Re: The Learning Center- TLE Saginaw- SUP

This letter shall serve as ClayMoore Engineering's written response to the drawing comments received. Responses are written in bold.

SITE PLAN

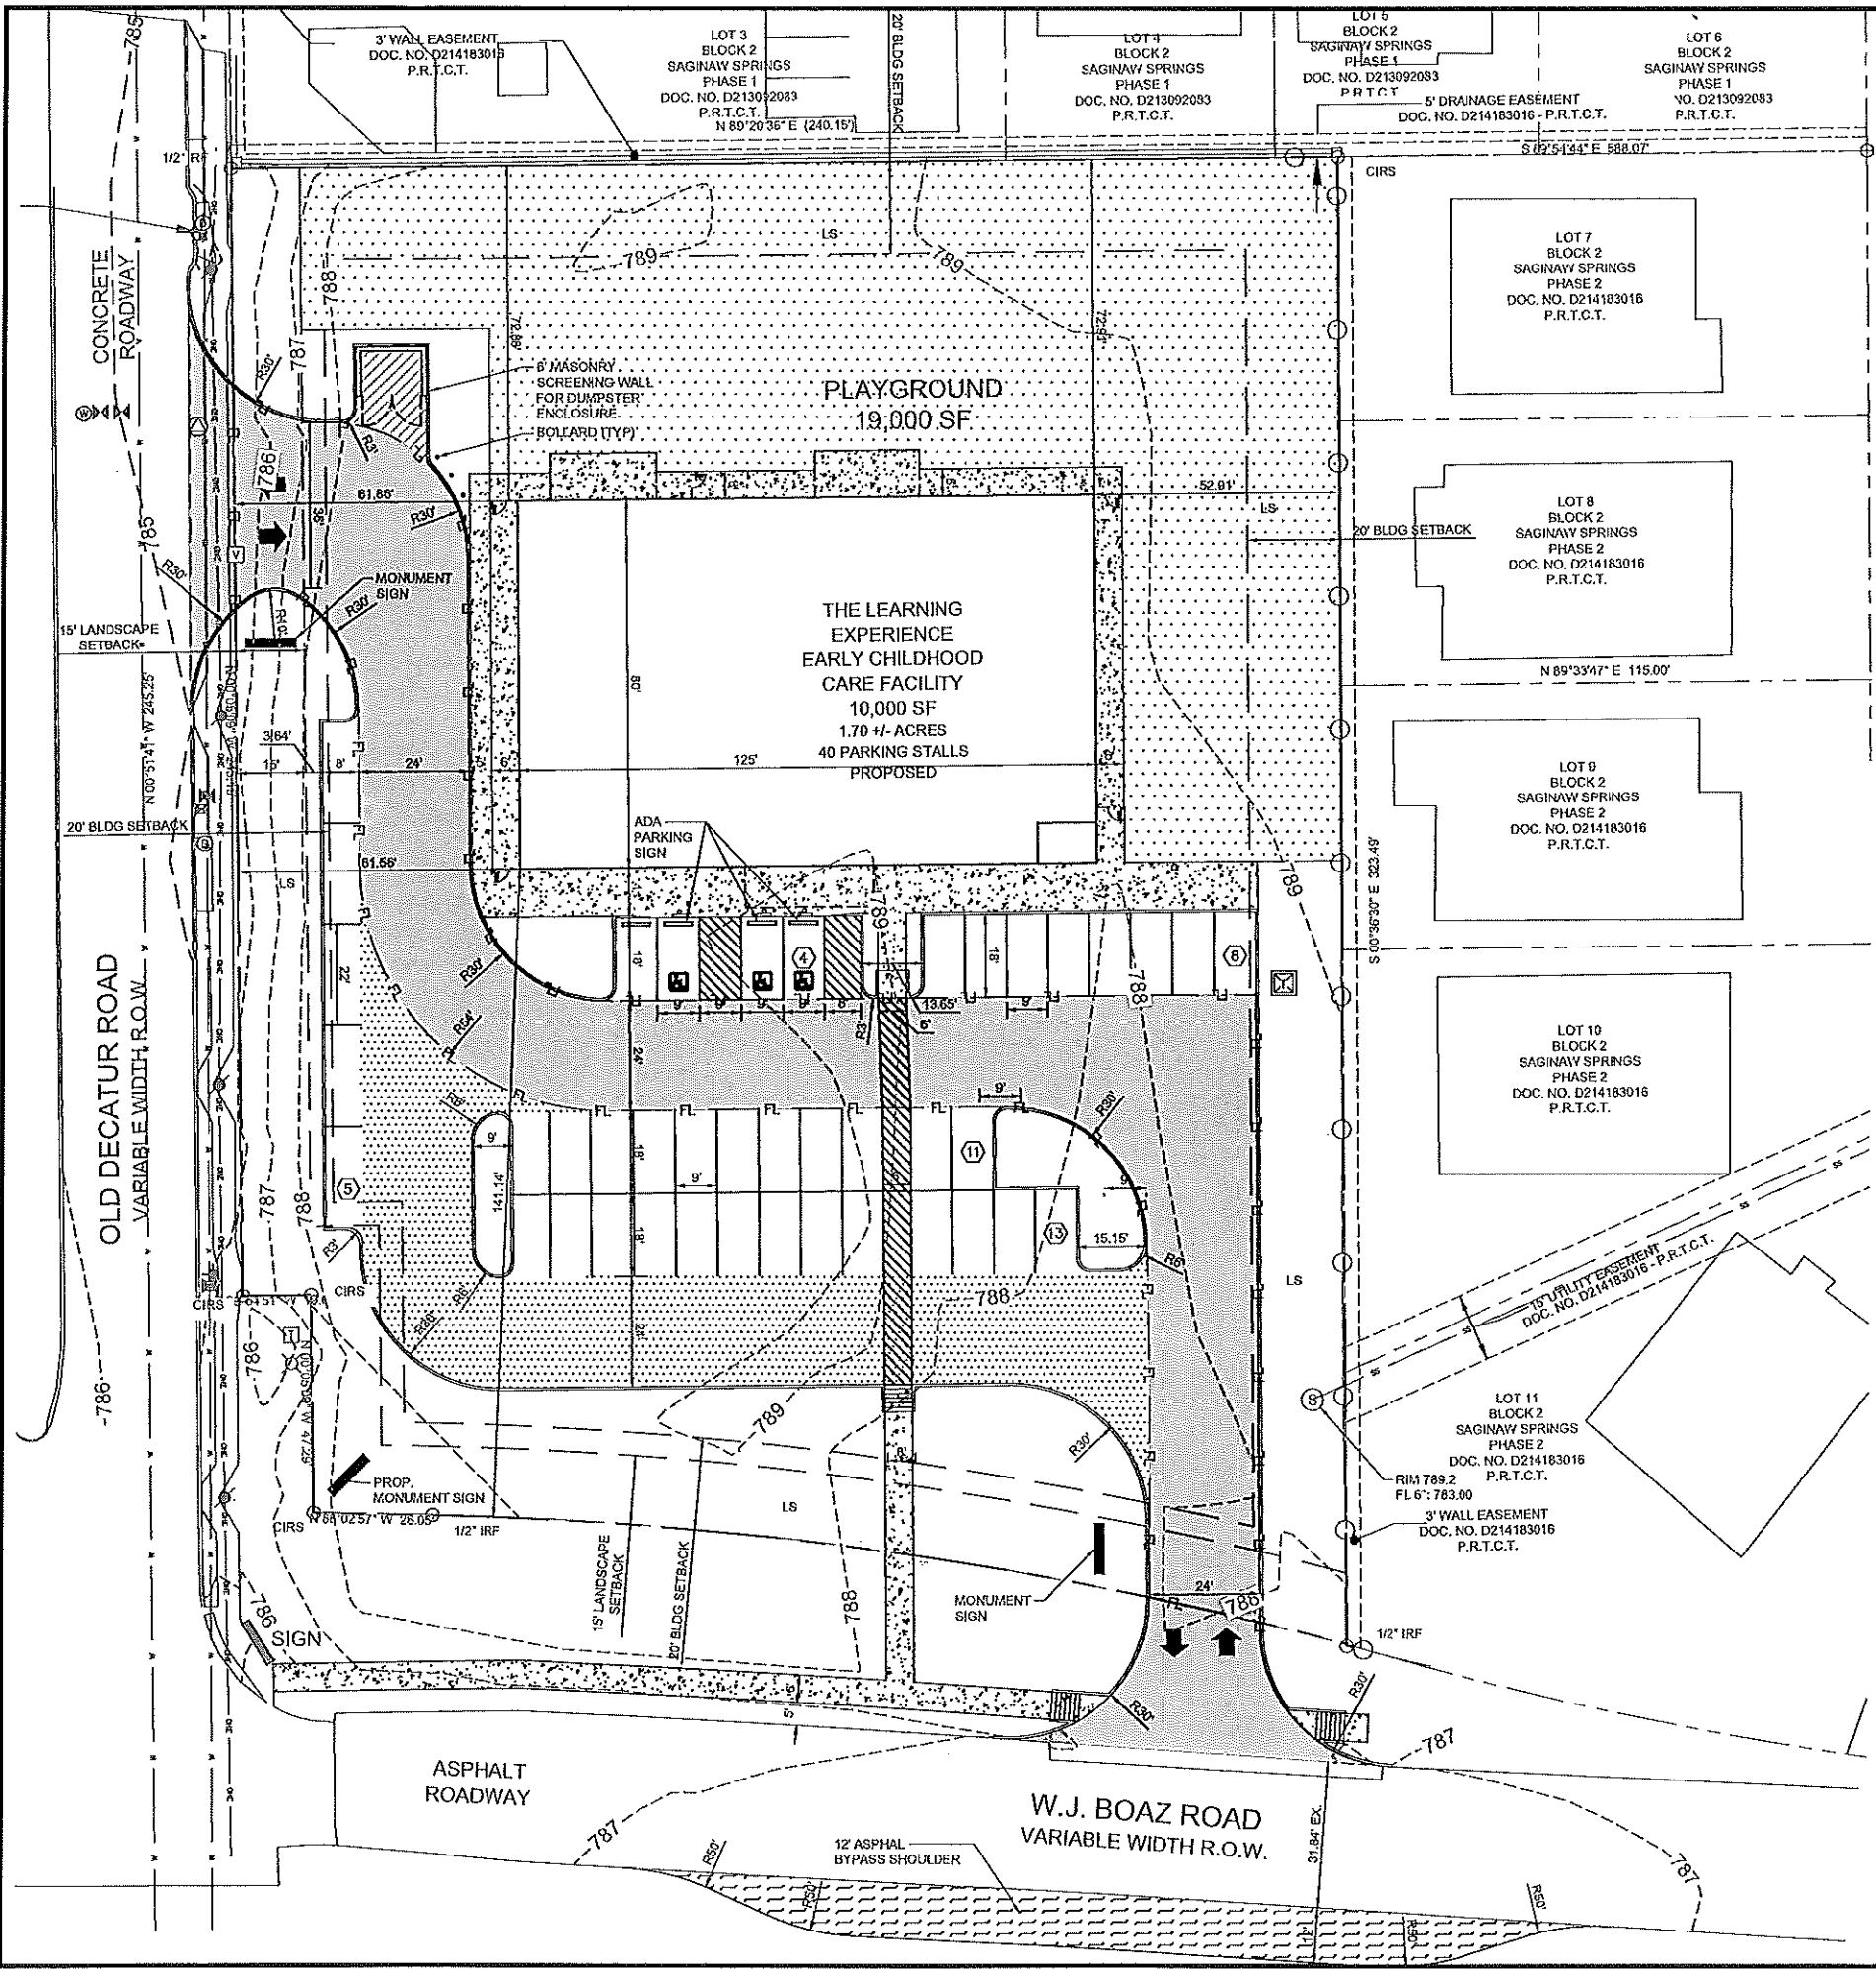
2. Provide asphalt shoulder to allow eastbound traffic to pass turning traffic.
WE WILL WORK WITH ENGINEERING TO PROVIDE A TURN AREA.
3. 30' required for all inside radii.
THE FIRE LANE RADII HAS BEEN ADJUSTED.

4. 100 square feet for each child required for outdoor play area. Zoning Ordinance 2002-04, Article 8, Section 8-6 B 2.
THE CURRENT SITE PLAN SHOWS 19,000 SF FOR THE OURDOOR PLAY AREA.

5. Provide drainage study with site detention.
A DRAINAGE STUDY BEING COMPLETED AND WE WILL WORK WITH THE CITY TO ENSURE THAT PROPER MEASURES ARE PROVIDED FOR THE DRAINAGE OF THE SITE. IT IS UNDERSTOOD THAT DETENTION IS LIKELY REQUIRED FOR THIS SITE TO NOT INCREASE FLOW DOWNSTREAM.

6. Please complete requirements for Article 8, Section 8-1-E-1. Specifically show available utilities (water and sewer).
WATER AND SEWER SERVICES ARE ADJACENT TO THE SITE AS COORDINATED WITH THE CITY. PLANS WILL BE UPDATED TO SHOW THE CONNECTIONS.

7. Show range of ROW.
THE SITE PLAN WILL BE UPDATED TO SHOW THE ROW ON BOTH SIDES.
8. Show limits and type of screening and location of all refuse storage areas. Article 8-1-E-9
THE DUMPSTER ENCLOSURE NOTE HAS BEEN REVISED.

9. Show the type, location, and quantity of all plant material used for landscaping. Provide landscape table. Section 8-1 E 9
A DETAILED LANDSCAPE PLAN WILL BE PROVIDED. ALL CITY REQUIREMENTS FOR LANDSCAPING WILL BE PROVIDED.

10. Show building setback lines. Article 8-1-E-7.
SETBACK LINES HAVE BEEN ADDED.
11. Show zoning on property and contiguous properties. Article 8-1-E-12.
SITE PLAN WILL BE UPDATED WITH THE ADJACENT ZONING.

12. Show buildings on exterior of the site that are within 25 feet of all property lines. Article 8-1-E-13.
THE SURROUNDING RESIDENTIAL HOMES OUTLINES HAVE BEEN ADDED.

13. Provide sidewalk connection to existing at Old Decatur Road.
THE SIDEWALK HAS BEEN ADDED.
14. ADA ramps at all driveway locations.
THE ADA RAMPS HAVE BEEN ADDED.

15. Relocate sign at Old Decatur and W. J. Boaz to accommodate ADA ramp.
SIGN HAS BEEN ADJUSTED AND MOVED OUTSIDE OF THE ROW.
16. Verify parking requirements. Section 8-9 A, Instructional, Day Care.
PARKING REQUIREMENTS CORRECTED.

17. Provide dimensions on assessable parking or detail.
ACCESSIBLE PARKING SPOTS DIMENSIONED.
18. Need to show detectible surface compliant with ADA where walks enter fire lane.

19. Correct "parkgin" to "parking".
"PARKING" SPELLING CORRECTED
20. What utility is in the 15' utility easement on the east side of property?
THE EXISTING OFFSITE UTILITY EASEMENT TO THE EAST OF THE PROPERTY CONTAINS A 6" SANITARY SEWER LINE AND MANHOLE.

21. Explain "enhanced paving". Note #4
ENHANCED PAVING NOTE WAS AN ERROR, AND HAS BEEN REMOVED.
22. Replace "town" with "City of Saginaw" in note #5.
"TOWN" REPLACED WITH "CITY OF SAGINAW" IN SITE PLAN NOTES.
23. Correct Radiuses to Radii in note #6.
"RADI" SPELLING CORRECTED.
24. Abbreviations: F. A. U. in table, FL on plan.
ABBREVIATION FOR FIRELANE, ACCESS AND UTILITY EASEMENT UPDATED TO CORRECTLY REFLECT THE LABELING ON THE SITE PLAN.
25. Add LS to abbreviations definitions
LS ABBREVIATION ADDED TO ABBREVIATION TABLE.

2. Parking reflects 18 inches deep, is this unobstructed by a bumper? If so, the clear length will need to be 18 total feet for every parking space.
PARKING SPACES ARE 18' IN LENGTH AND WHERE ADJACENT TO FLUSH CURB IN FRONT OF BUILDING, WHEEL STOPS HAVE BEEN PROVIDED.

3. Fire lane is adequate in terms of the width 24 minimum as long as parking is not allowed in this area. Minimum vertical height 13.6 inches
24' FIRE LANE WIDTH IS EXCLUSIVE OF ANY PARKING AREAS. NO OVERHANGS IN THE FIRE LANE ARE PROPOSED, SO MINIMUM OF 13.6' OF VERTICAL CLEARANCE IS MAINTAINED ALONG ALL POINTS OF FIRE LANE.

4. One section of this building is over 150 feet from the fire lane. The fire lane or the building will need some work to ensure that no portion of the building is greater than 150 from the center of the fire lane.
FIRE LANE ALIGNMENT HAS BEEN ADJUSTED SO THAT NO PORTION OF THE BUILDING IS GREATER THAN 150' FROM THE CENTER OF A FIRE LANE.

5. Fire lane radius 30 inside radius required on the fire lane. It appears that some additional work may be required here.
INSIDE RADIUS OF FIRE LANE ADJUSTED TO BE 30' MINIMUM.

6. At this point we have no other concerns other than water supply. Do we have any hydrants to propose on this project or will that come later?
FIRE HYDRANTS HAVE BEEN ADDED.
